DA7-A100 ISSUE H IF IN DOUBT-ASK
 FIRST W.O.

SHEET 1 OF 1 SHEETS

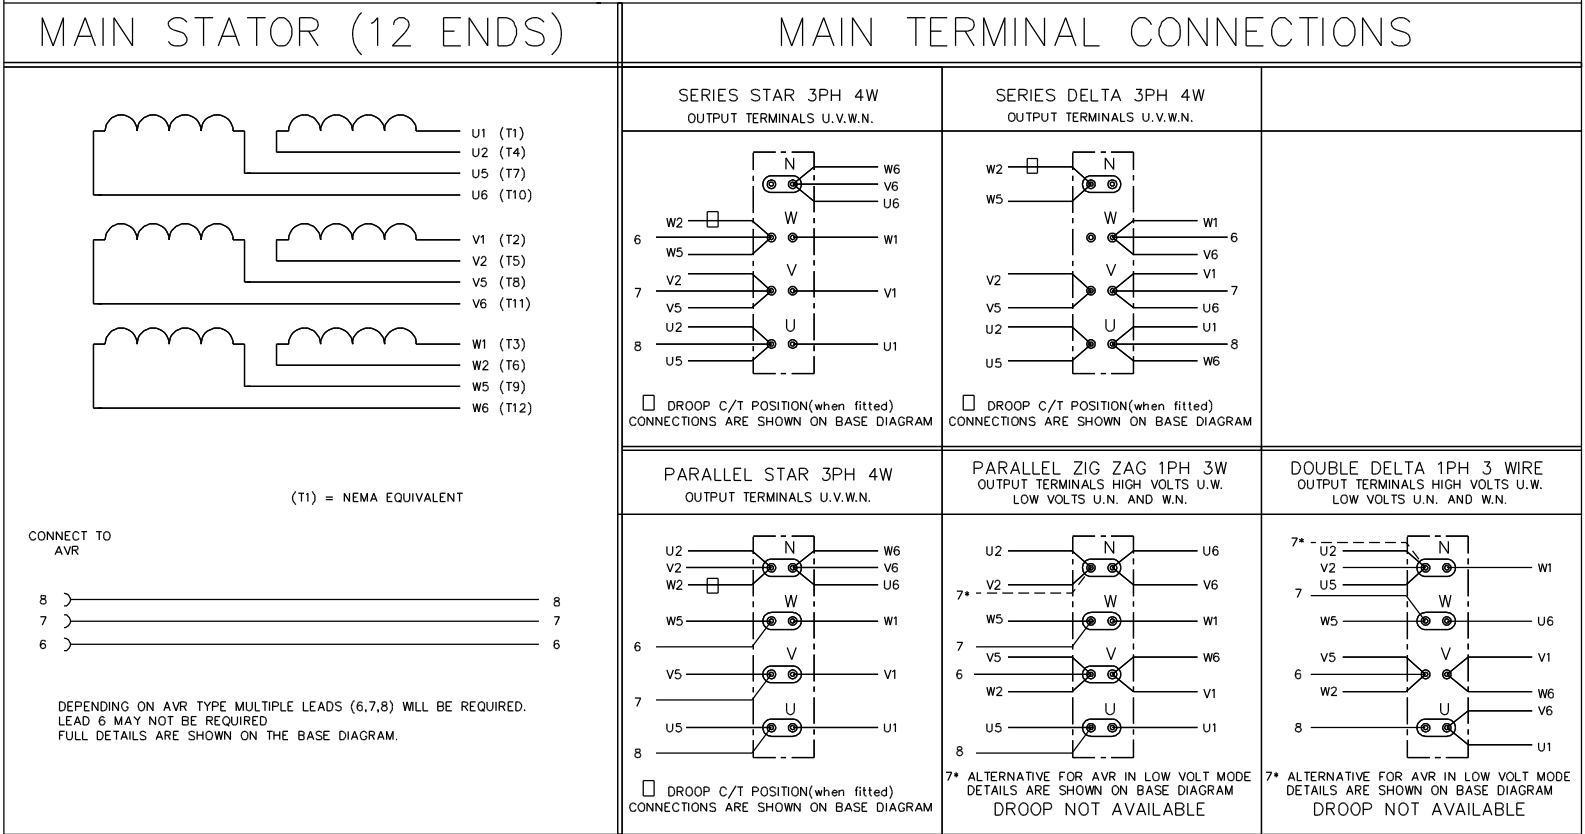
3/9964	H	S.H.	11:4:95	DOUBLE DELTA CONNECTION - CENTRE POINT CHANGED FROM W TO N	<h2 style="margin: 0;">CONNECTION DIAGRAM</h2>			
3/9728	G	S.H.	13:12:94	DOUBLE DELTA CONNECTION BROUGHT IN LINE WITH STATOR LEAD EXIT POSITIONS				
3/9572	F	S.H.	17:10:94	OUTPUT TERMINALS - PARALLEL ZIG ZAG AND DOUBLE DELTA CHANGED	CERTIFIED PRINT	FRAME ---	OTHER FEATURES	
3/9324/1	E	S.H.	4:7:94	DOUBLE DELTA - NOW IN LINE WITH LINK BOARD VERSION	(ONLY IF SIGNED)			
3/8946/2	D	MLW	25.1.94	PARALLEL ZIG ZAG ADDED	BY	CONTROL SERIES ---		
3/8946/1	C	MLW	13.1.94	DOUBLE DELTA CONNECTION ADDED, PARALLEL ZIG ZAG DELETED	DATE	POLES		
3/8428	B	P.N.	17:3:93	DELTA CONNECTION U1 WAS U6 AND U6 WAS U1 ETC	No. OF ENDS	12		
3/8192	A	P.N.	5:1:93	ORIGINAL ISSUE	DRAWN	P.N. 5:1:93	SENSING 2/3 PHASE	
MOD.	ISS.	DRN.	DATE	ALTERATION	CH'D		NEWAGE INTERNATIONAL Ltd	
					APP'D		STAMFORD, ENGLAND	
							DA7-A100	ISSUE H
